Re: Bellevue City Council East Link Alignment Preferences

# Bellevue's Preferred East Link Light Rail Route

The purpose of this letter is to formally transmit to Sound Transit the City of Bellevue's technical review comments on the East Link Draft Environmental Impact Statement (DEIS). The City recognizes the commitment of effort and resources by Sound Transit to conduct an environmental analysis on a project of this scale and complexity. We appreciate the additional time provided by the extended 75-day comment period and the collaborative approach to public involvement to reach out to a broad range of stakeholders. The City of Bellevue and Sound Transit have worked diligently over the course of this project to foster a strong working relationship that is respectful of our mutual and individual objectives. We look forward to building on this relationship as we jointly work through the City's comments on the DEIS to assist Sound Transit in developing a Final EIS that meets our mutual needs.

## East Link DEIS - Bellevue staff comments

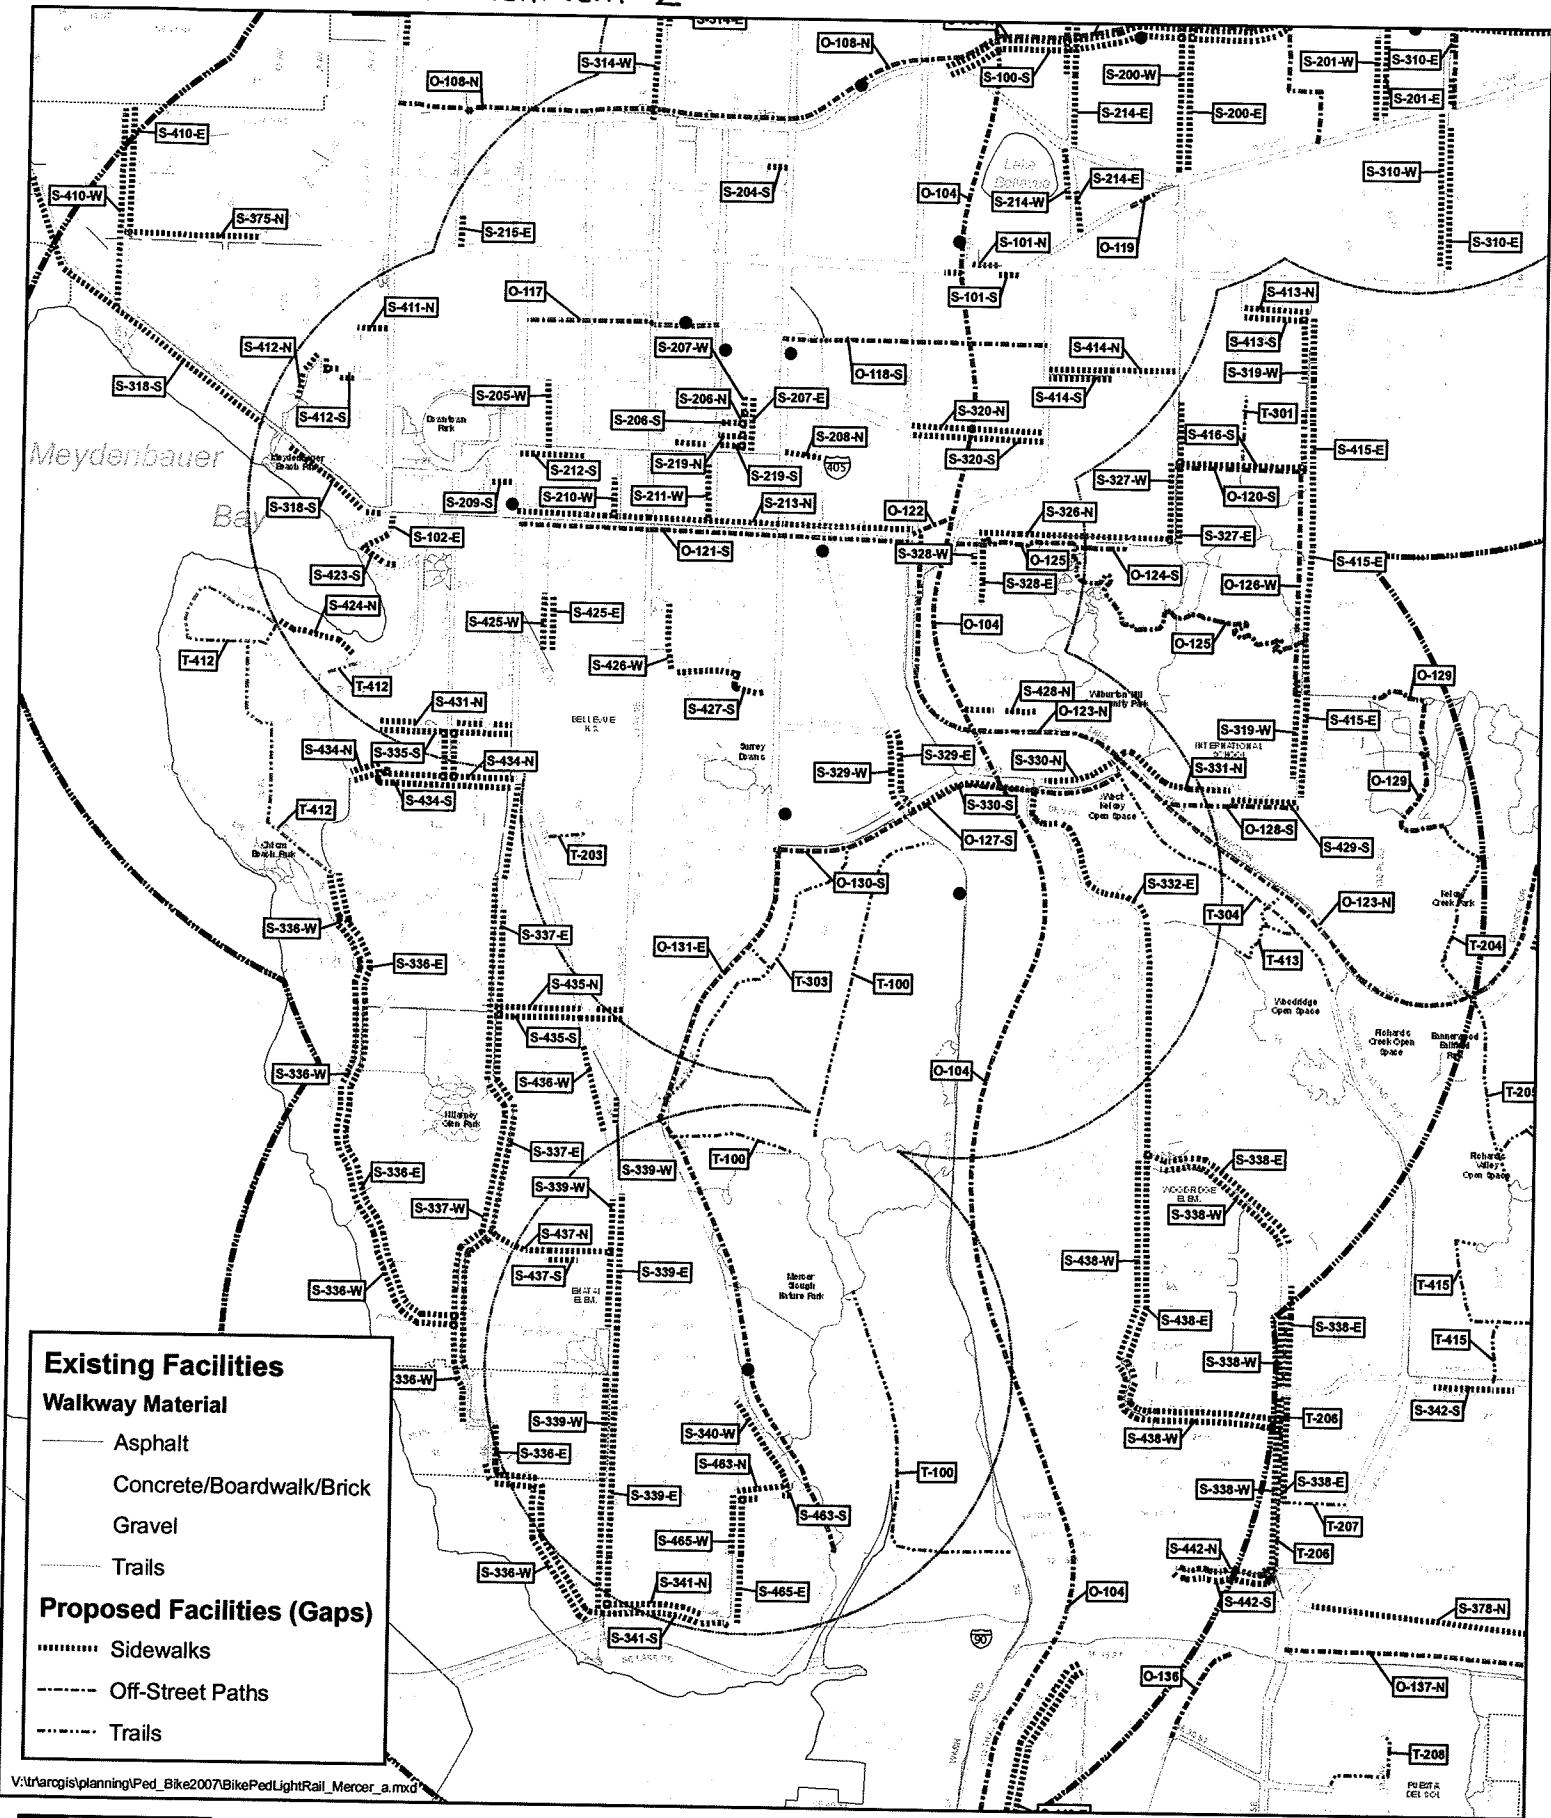
685 Appendix H1	7-6	Table 7-2: Sound Transit is encouraged to revise Table 7-2 so that it conforms with the City of Bellevue's Sidewalk and Bicycle Gap Analysis (see attached spreadsheet). The non-motorized facility gaps are derived from 1/2 mile sidewalk study area and 1 mile bicycle study area data from the City of Bellevue's 2009 Pedestrian and Bicycle Transportation Plan.
686 Appendix H1	7-7	Exhibit 7-3: In a number of instances, the sidewalk gaps (SWG) and bike route gaps (BRG) identified in Exhibit 7-3 do not conform to existing conditions in Bellevue. By way of example, SWG-13 is identified as a missing sidewalk segment on SE 25th Street (104 Ave SE to Bellevue Way SE) when there is an existing sidewalk on the south side of the street along this street. Additionally, Exhibit 7-3 does not conform in a number of instances to the City's 2009 Pedestrian and Bicycle Transportation Plan (scheduled for Council adoption in Jan/Feb 2009). By way of example, the City's 2009 Plan calls for a 5 foot wide sidewalk on both the east (S-465-E) and west (S-465-W) side of 112th Avenue SE from SE 30th Street to SE 34th Street where not complete. Sidewalks on 112th Ave SE would appear warranted in the East Link DEIS given their proximity to the South Bellevue Station. Sound Transit should revise Exhibit 7-3 so that it conforms with the City of Bellevue's Sidewalk Gap Analysis (see attachments 2 - 5 maps).
